Re: Response to Sydney North Planning Panel Deferral Notice (PPSSNH-506 – DA2024/106)

Gyde Consulting act on behalf of the applicant SJD NB Pty Ltd., regarding the proposed development application (DA-2024/106) at 57-69 Strathallen Avenue, Northbridge. We write in response to the 'Record of Deferral' Notice issued by the Sydney North Planning Panel (the Panel), dated 5 June 2025.

Figure 1 Extract of Drawing No. A03.102 prepared by Bates Smart Architects, noting the amendments to GFA within the proposed development

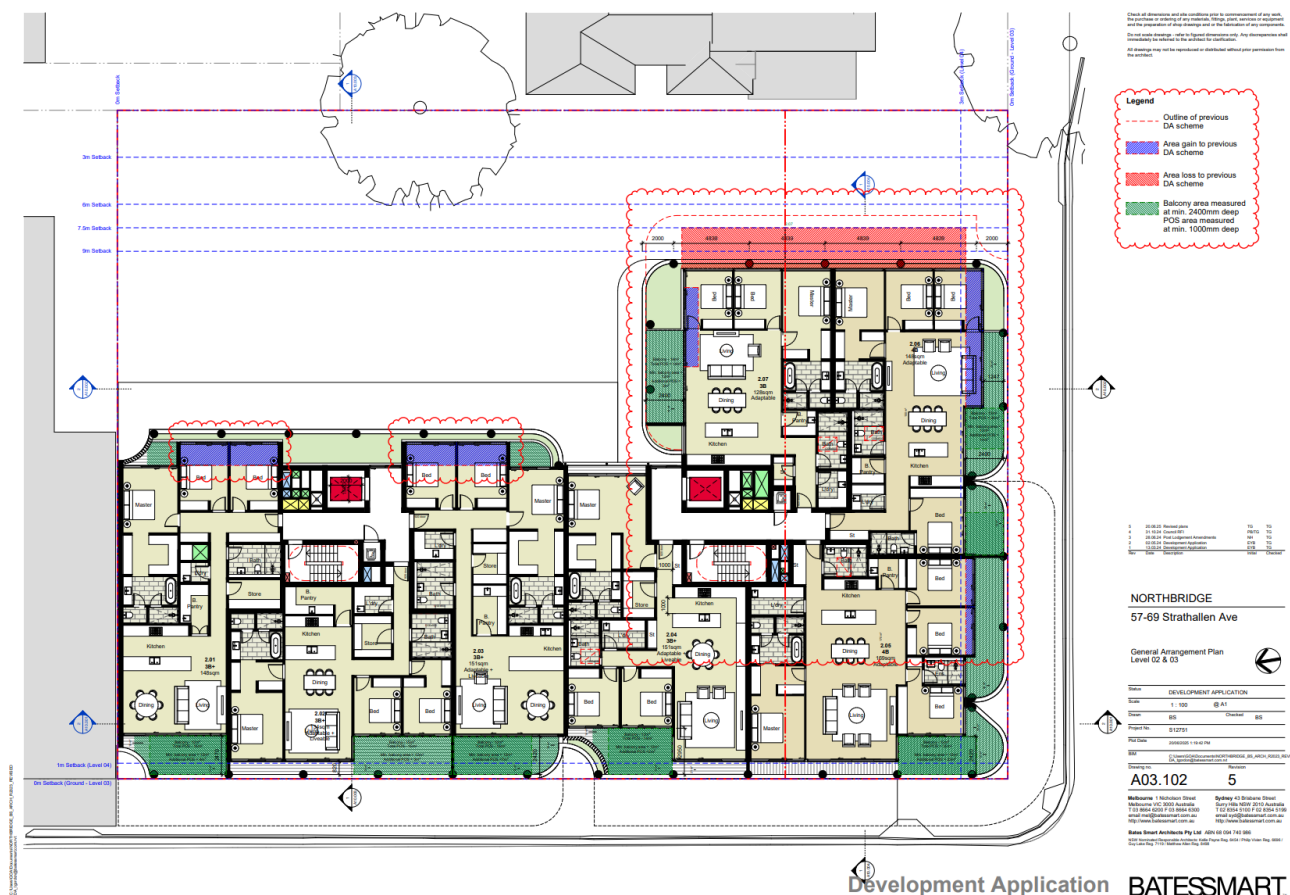
In response to the Panel's request, the applicant and design team have made targeted reductions to the gross floor area (GFA) on 57 Strathallen Avenue. These changes reduce the overall built form at the southern end of the site and significantly minimise potential view impacts.

Previously, the GFA on 57 Strathallen Avenue exceeded the permitted 1,518 sqm (based on a 2.5:1 FSR) by 46 sqm, representing a 2.99% variation. Following a design review by Bates Smart Architects, the GFA has been reduced—particularly along the eastern boundary, where view loss was a key concern raised by the Panel and Council. A portion of the GFA has been shifted to 59–69 Strathallen Avenue, where there was capacity under the allowable limit. Due to the orientation of the site, despite the slight increase in GFA to 59–69 Strathallen Avenue, the adjoining residences still maintain the minimum solar access required under ADG provisions.

- The GFA on 57 Strathallen Avenue is now **8 sqm below** the permissible GFA
- At 59–69 Strathallen Avenue, where the site was previously 90 sqm below the permissible GFA, the updated design now remains **55 sqm below** the permissible GFA.
- The total development across both sites is now **63 sqm below** the permissible GFA.
- The total FSR of 2.10:1, across both sites, is under the 2.13:1 permissible.

A detailed summary of the permissible, previously proposed, and amended GFA and FSR is provided in Table 2 below, with amendments shown in blue. The architectural plans prepared by Bates Smart Architects have been updated to reflect these amendments. An extract of Level 02-03 General Arrangement is provided in Figure 1, the amended plans reflect the reduced GFA in red hatching, and the shifted GFA in blue hatching. The amended design maintains compliance with all other applicable LEP and DCP controls, as with the original proposal.

Figure 2 Amended height plane noting the southeastern corner has increased from 0.31m to 0.325m (Note: This image reflects height exceedances only and is not an accurate representation of amended built form)

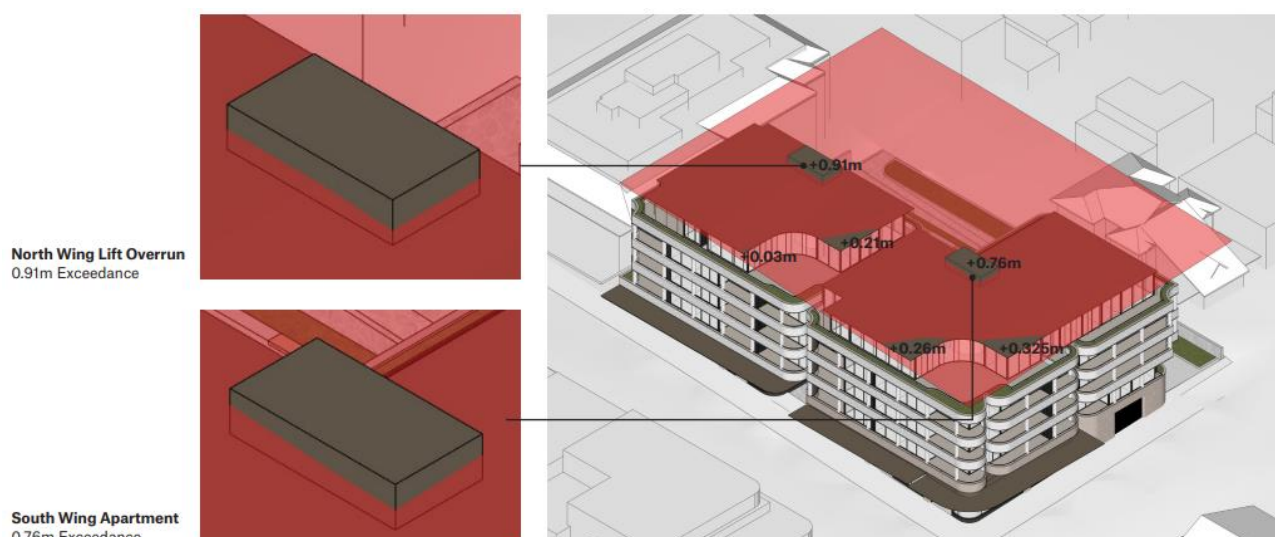
It was presented to Panel on 4 June 2025 that the building height exceedances are minor in nature, and do not contribute to the loss of views, only views to sky. Agreement to this point was noted by Council's Independent Assessor in the meeting that took place 11 June 2025 (Refer to Item 3 in Appendix A).

The shifting of GFA as noted in Section 1.1 of this Letter results in a very minor height amendment to the southwestern corner of 15mm. The Clause 4.6 Variation Request for Height of Buildings (dated 20 June 2025) has been amended to reflect this minor change, and similarly, to provide a more robust assessment of view impact with consideration of the additional information provided in the VIA prepared by Urbaine Design.

The proposed exceedances are as follows in Table 3 and Figure 2, noting the amended exceedance is marked in blue. This amendment does not result in any additional view loss, considering it is extremely minor, it maintains only view loss to sky, as per the original proposal.

Figure 4 Extract of Viewpoint 11 extracted from the VIA prepared by Urbaine Design dated 20 June 2025

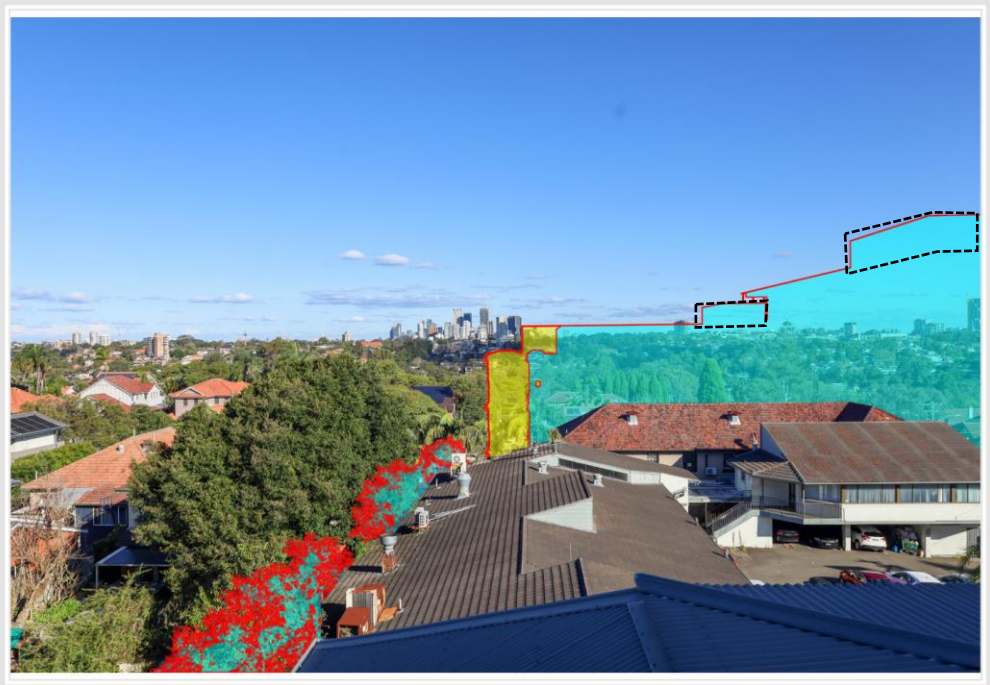
It was noted by Council's Independent Assessor in the meeting that took place on 11 June 2025 (Refer to Item 3 in Appendix A), that when preparing the amended VIA, the applicant team is to consider exploring alternative designs that may show how reducing the FSR contravention (specifically the eastern edge of the building on the Northbridge Hotel site (57 Strathallen Avenue)) could improve view sharing to the city skyline, demonstrating a "reasonable gesture".

Taking into account the reduced GFA to the southern portion of the site, particularly to the eastern boundary, as a result, the view impact has been significantly reduced. The building, which now complies with the FSR control, successfully minimises view loss and allows for greater view sharing from 128 Sailors Bay Road. We wish to highlight the following positive outcomes:

- areas that relate to the greatest height exceedance being the lift overruns attribute only to minor parts of view loss to sky,
- the area of the southwestern corner that has minorly increased from 0.31m to 0.325m does not result in additional view loss as it is obscured by compliant elements of the built form,
- the GFA reduction to the eastern boundary minimises view loss, with some views regaining a large portion of their view to North Sydney CBD, Sydney CBD, and in particular, the Centrepont Tower. The VIA prepared by Urbaine Design notes that *“the proposed set back of the eastern facade, from the boundary, results in a significant view gain, when compared to the original Application. This is, crucially in relations to the highest value components of the view, to the south, including Sydney and North Sydney CBDs”*.

Figure 9 Proposed communal open space (Extract of Drawing No. A03.100 prepared by Bates Smart Architects)

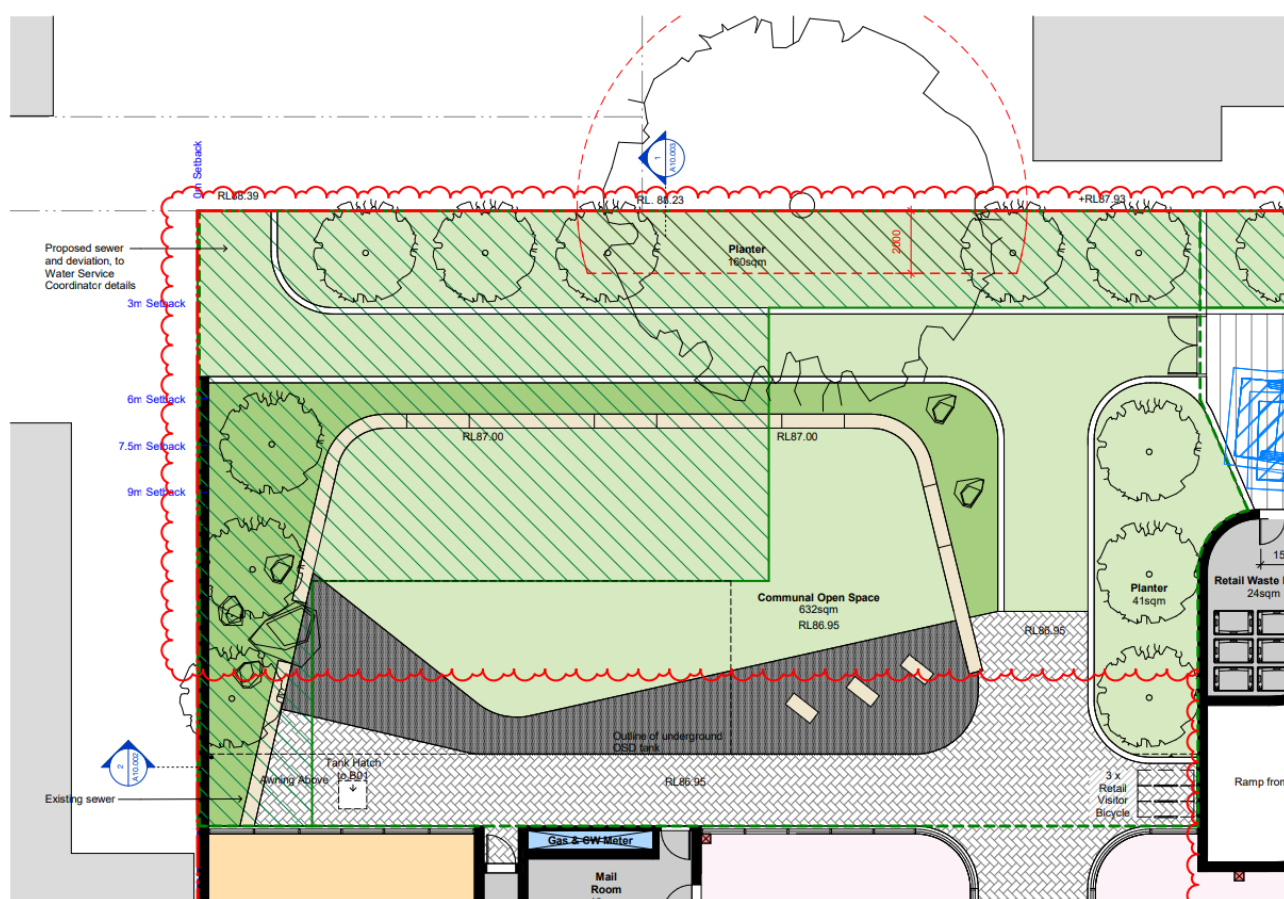
It was noted by the Panel that clarification is required around the communal open space, and public open space proposed. The applicant has understood there is some concern that the communal open space proposed may not be considered as “genuine” communal open space.

As a result of concerns raised, minor amendments and clarification of the ground level layout are proposed. The proposed development provides provisions for a future through-site link as noted above in Section 3.1, however, the certainty of whether this will come to fruition is unknown. The amended proposal seeks to provide the same communal open space layout as the original proposal, however, the area comprising what would have been the through-site link, is proposed to be a turfed grassed area which can be utilised for passive recreation by residents, until such time as it is required to be dedicated as a through-site link.

The communal open space is proposed for residents use only, which comprises 632 sqm (26%), and therefore complies with the ADG requirement of 25%. The architectural drawings prepared by Bates Smart Architects (dated 20 June 2025) have been amended to reflect this accordingly, an extract of Drawing No. A03.100 is provided overleaf in Figure 9.

Figure 10 Proposed communal open space to be provided at such time that a through-site link eventuates (Extract of Drawing No. A03.100_A prepared by Bates Smart Architects)

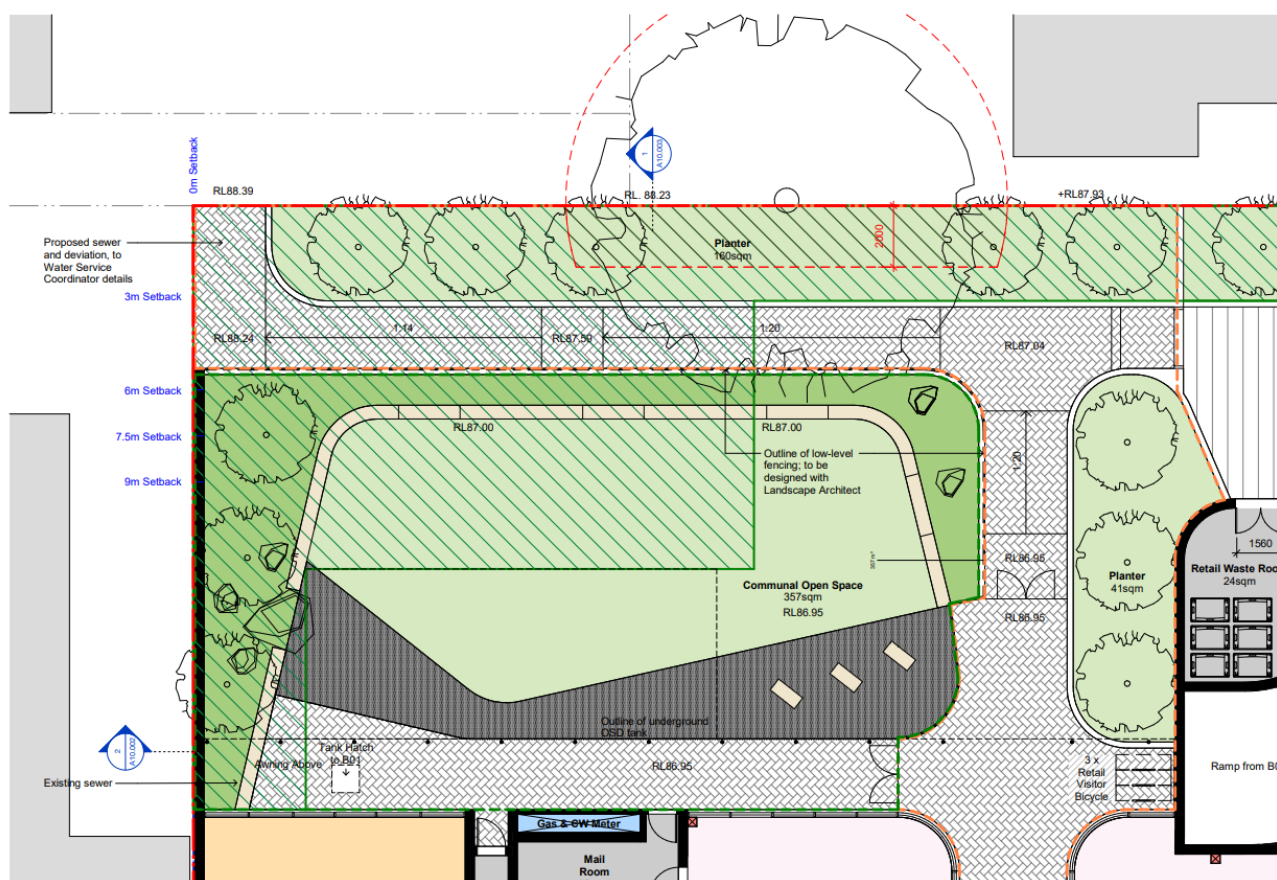
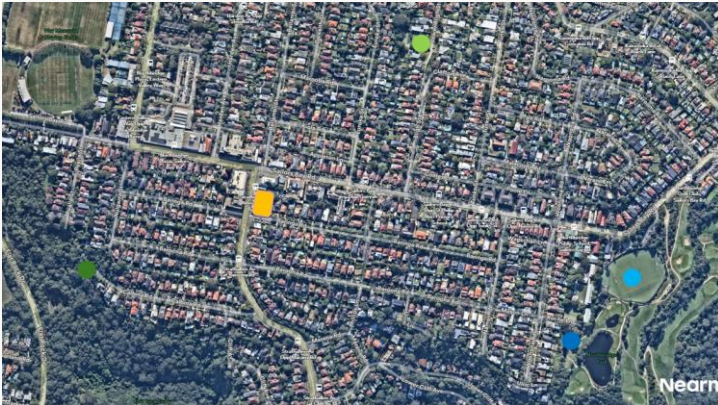
Should the through-site link eventuate in the future—as outlined in Section 3.1 of this letter and subject to the future redevelopment of 134 Sailors Bay Road—we propose a condition of consent that would require the applicant to deliver the link at that time. The following condition of consent is proposed:

An easement is to be registered on title over the area identified as a potential through-site link within the communal open space. This easement shall be dormant until such time that a connection to 134 Sailors Bay Road is facilitated through future redevelopment.

In the event the through-site link is required in the future, the applicant (or future owner) must be responsible for retrofitting the communal open space area to provide a publicly accessible, functional, and compliant through-site link in accordance with Council's requirements. The design and delivery of the link is to be at no cost to Council and must ensure continued amenity for adjoining residents where practical. Details of the proposed fencing, gate and any landscaping changes are to be submitted as part of the easement documentation.

Upon activation of the through-site link, the remaining communal open space is to be appropriately sectioned off to maintain security and amenity for residents. This is to be achieved through the installation of a 1.8-metre high mesh pool-style fence in dark colour, appropriate landscaping, and a gate to clearly define the private resident-only areas.

With regard to the above, we wish to refer Council and the Panel to Drawing No. A03.100_A prepared by Bates Smart Architects, extracted below at Figure 10, which indicates how a through site link could be integrated. The condition above, would ensure that if this were to eventuate, that residents would have access to a private communal open space, separate to the public areas, cognisant of CPTED principles in the nomination of pool-style fencing in a dark colour, and appropriate landscaping.

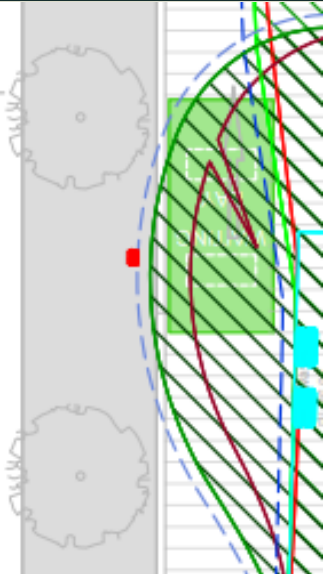
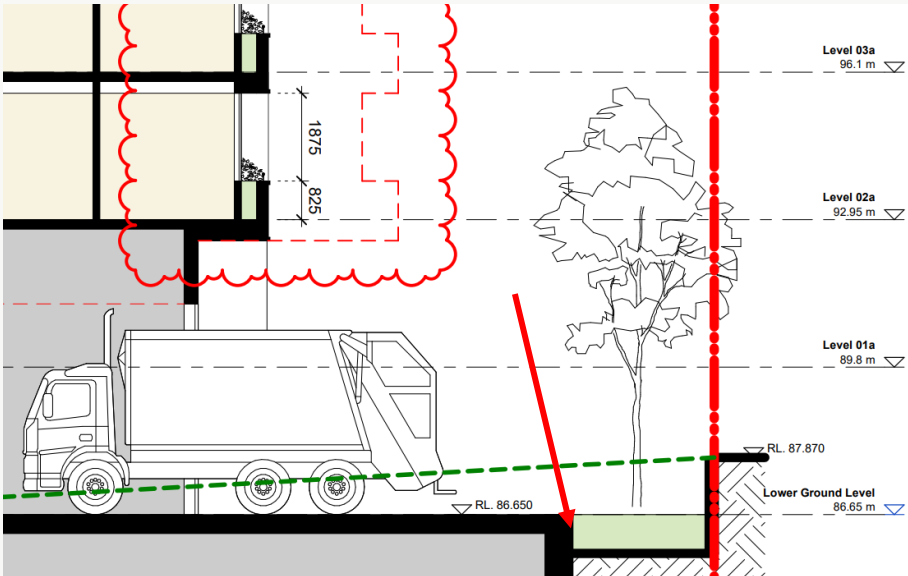
Items raised by Council	Response
<i>Confirm the truck swept path (10.5m HRV waste truck) and diagram to state compliance with AS2890.2.</i>	<p>MLA Transport Planning have confirmed that the swept path analysis for the 10.5m HRV waste truck does comply with AS2890.2. The swept path diagrams have been provided by MLA Transport Planning, and are provided at Appendix F. A Transport Memo has been prepared by MLA Transport Planning responded to this matter (dated 20 June 2025).</p> <p>AS2890.2 does not contain specific wording that permits parts of a vehicle to overhang into a non-hard surface area when performing a vehicle manoeuvre. However, it is noted that Clause 1.4.23 in AS2890.2 defines “swept path” as the “area which is traced by the extremities of the bodywork of a vehicle while turning” and Clause 5.1 requires that swept paths be checked to ensure sufficient clearance. It does not specify or require that the entire swept path be located within a paved or hard-surfaced area, only that it be clear of obstructions. In addition, AS2890.2 defines “apron” and “manoeuvring area” (Clauses 1.4.2 and 1.4.11) but does not specify that these areas must be hard-surfaced or paved. The focus in AS2890.2 is on providing minimum requirements for functional manoeuvrability and safety.</p> <p>As such, from a practical point of view, we interpret the Australian Standard as having no requirement that all parts of the vehicle to remain within a hardstand, nor any restriction against overhangs extending over non-trafficable areas such as turfed area, provided the area tracked by the tyres of the vehicles is on a hard surface and the body of the vehicle remains clear of obstructions.</p> <p>The overhang of the truck minorly extends into the 3m landscape buffer that extends along the eastern boundary. An extract of the swept path analysis diagrams has been provided below in Figure 12, which shows the body of the truck extend into the 3m landscaped buffer. We note that the interface between the hard paving, and the landscaping, will be at one level, with no kerb proposed. The landscaped area will be turfed and no shrubs or trees will be planted toward the outer edge of this area. Therefore, any minor encroachment of the overhang of a truck into this area will not result in damage to the landscaping at this area. See Figure 13 overleaf for an extract of Drawing No. A10.004 prepared by Bates Smart Architects which illustrates this treatment at one level.</p>

Figure 14 Extract of Drawing No. A10.004 prepared by Bates Smart Architects illustrating clearance zones to rear of loading area

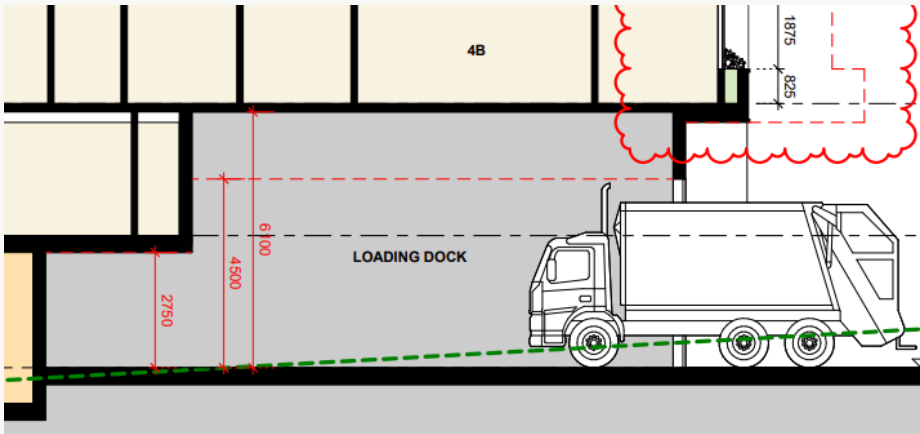
<p>Council's Waste Consultant noted that <i>proximity of temporary holding areas to the loading area where the truck rear is at the back of the parking space (12.5m long parking space to allow the extra 2m rear clearance space for loading). The DCP requires holding areas to be 2m (possibly 10m) from the loading area. Can you state the distances and keep them as close as possible, noting the current design and limitations of being able to substantially amend that now.</i></p>	<p>The loading bay extends 11.5 metres in length, with a 1.904-metre clearance to the rear to allow for waste loading, all within a 4.5-metre high clearance zone suitable for this function. At the front of the bay, an additional 1.470 metres is provided as a buffer to support safe waste collection and loading operations. Whilst 3.5 metres is available to the rear of the waste truck, this area has a reduced height clearance of 2.75 metres. However, it remains functional for the positioning and handling of waste bins during loading (refer Figure 14).</p> <p>Waste trucks can also be positioned slightly forward within the bay due to the front buffer, which facilitates a closer alignment between the truck and the waste holding rooms. The distances from the truck to the waste/general holding room and the bulky/organics holding room are approximately 3 metres and 11 metres, respectively (refer Figure 15). Although the distance to the bulky/organics room exceeds the preferred 10-metre guideline, this only constitutes a very minor shortfall of approximately 1 metre. Furthermore, Council's Waste Consultant previously indicated support for this arrangement, acknowledging the constraints posed by the ground level design (Appendix B).</p>

Figure 16 Extract of Drawing No. A03.100 prepared by Bates Smart Architects, identifying the waste arrangements as discussed in Table 6 above

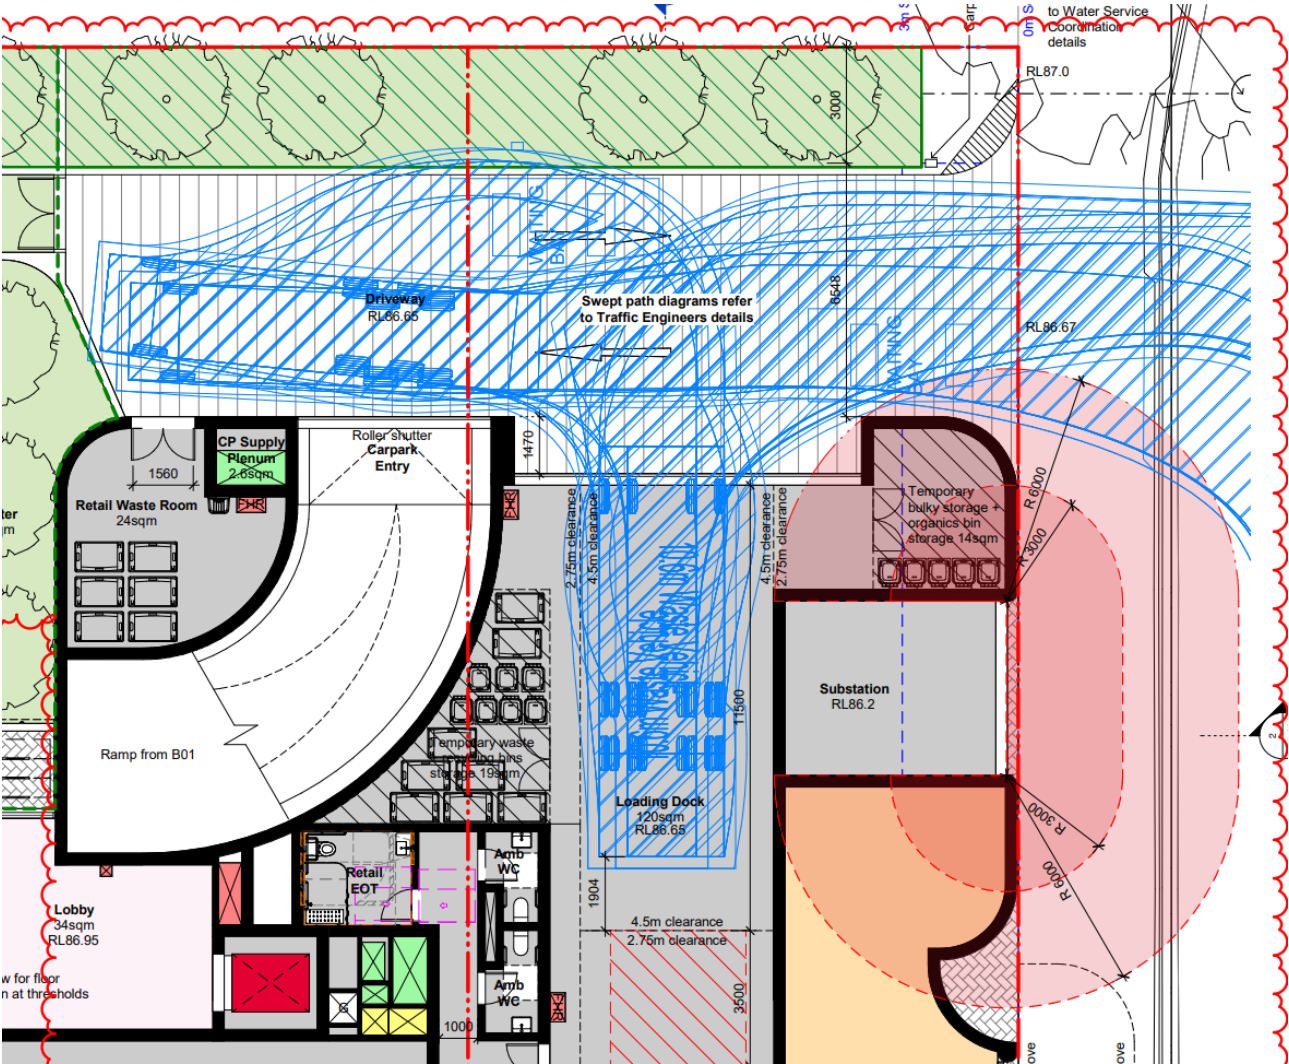
Council's Waste Consultant questioned whether there is suitable aisle width around the truck to wheel bins and carry bulky waste when the truck is parked.

Suitable aisle width has been provided to ensure that bins can be wheeled, and bulky waste can be carried, around the truck when it is parked. 2 meters can be provided on either side of the truck, dependent on whether loading of the recycling and general waste, or the bulky waste and organics room is taking place. An extract of Drawing No. A03.100 prepared by Bates Smart Architects is provided overleaf in Figure 16.
